CITY OF PLANO COUNCIL AGENDA ITEM

| Consideration of an Appeal of the Heritage Commission's Denial of a Certificate of Appropriateness to demolish the existing detached garage at 813 E. 18th Street to construct a 2,208 square foot single story building. Zoned Retail (R), Heritage Resource #20 Designation (H-20). Applicant: Bill Lisle III | | | | |

AGENDA ITEM NO. 8 - CERTIFICATE OF APPROPRIATENESS HC-2014-06
813 E. 18TH STREET
APPLICANT: BILL LISLE III

Certificate of Appropriateness (HC-2014-06): 813 E. 18th Street

1 PROPOSED SITE PLAN
SCALE: 1" = 20'-0"

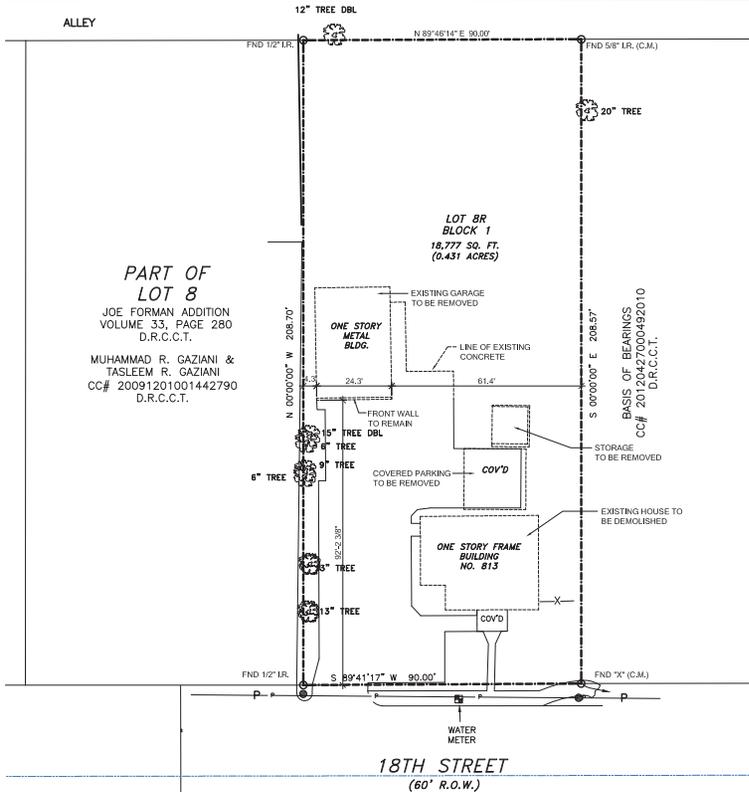
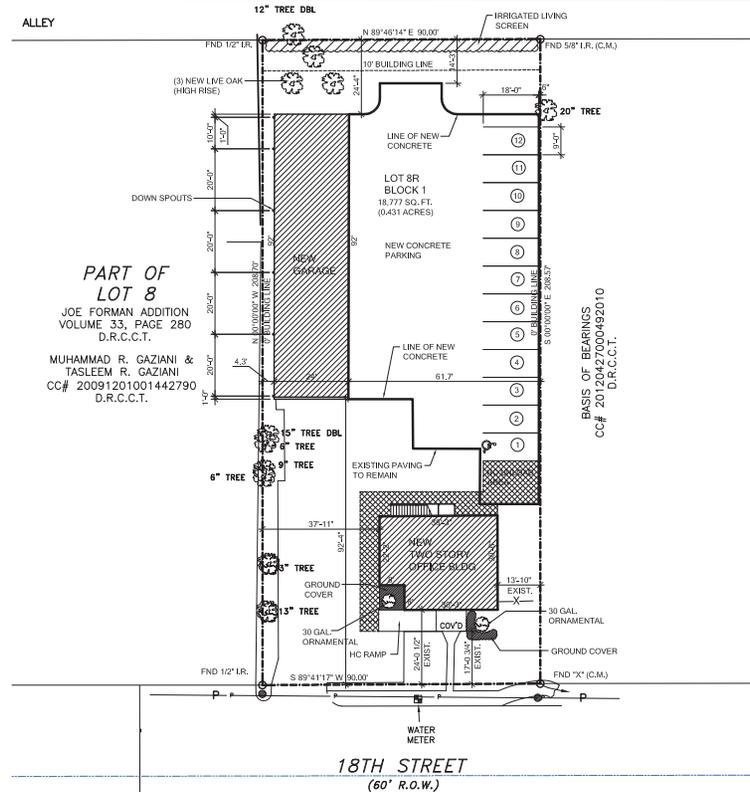
The Commission stated that the proposed CA application to demolish the existing detached garage to construct a new secondary building is incomplete without an updated site plan. The Commission further agreed that based on the information provided by the applicant, the proposed structure's compliance with the existing Haggard Park Heritage Resource District Preservation Guidelines could not be determined. A simple majority vote of 5 of the 8 City Council members is required for approval of the appeal request.

The Heritage Commission denied the CA request stating that this is an incomplete CA application and does not have an updated site plan. The Commission agreed that based on the information provided, they cannot judge the proposed structure's compliance with existing guidelines.
